**File No. 3/02/035**

## **BUILDING AND DEVELOPMENT TRIBUNAL - DECISION**

**Site Address:** 147 Rubicon Crescent Kuraby

The appeal is against the decision of the Brisbane City Council not to grant approval for the siting of a retaining wall constructed at a height of 3000mm on land described as Lot 186 on SP No 113035 and situated at 147 Rubicon Crescent, Kuraby.

□ SITE PLAN NOT TO SCALE.

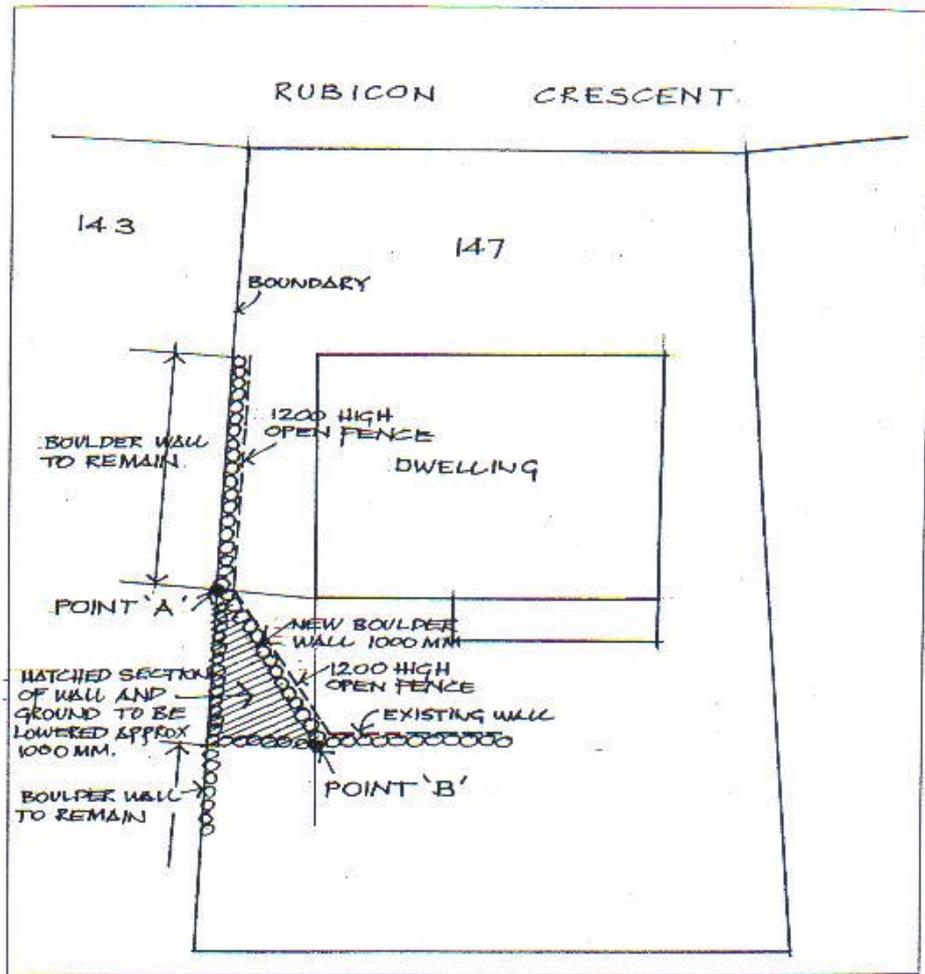
- (a) The existing retaining wall closest to the front of the allotment from the front line of the dwelling to a point (Point A) in line with the rear corner of the dwelling remains as constructed.
- (b) The remaining retaining wall is lowered in height by approximately 1000mm from a point (Point A) on the boundary of 143 Rubicon Crescent Kuraby in line with the rear corner of the dwelling and measured at 90 degrees to the boundary and a point (Point B) in line with the side wall of the existing dwelling and located on the existing rock retaining wall approximately 4000mm from the rear of the existing dwelling.

- (c) Adequate precautions are taken to avoid the discharge of rainwater and seepage onto the adjoining allotment; and
- (d) A 1200 high open safety fence (pool fencing type design) is located on top of the existing retaining wall from a point in line with the front wall of the existing house, for condition (a) and on top of the repositioned wall for condition (b) and joining the two points described in that condition.
- (e) The type and extent of safety fence may be changed by agreement with the owner of 143 Rubicon Crescent Kuraby.
- (f) The modifications to the retaining wall and the erection of the safety fence are to be completed within four months of the date of this decision.

The above conditions are to be in accordance with the attached plan.
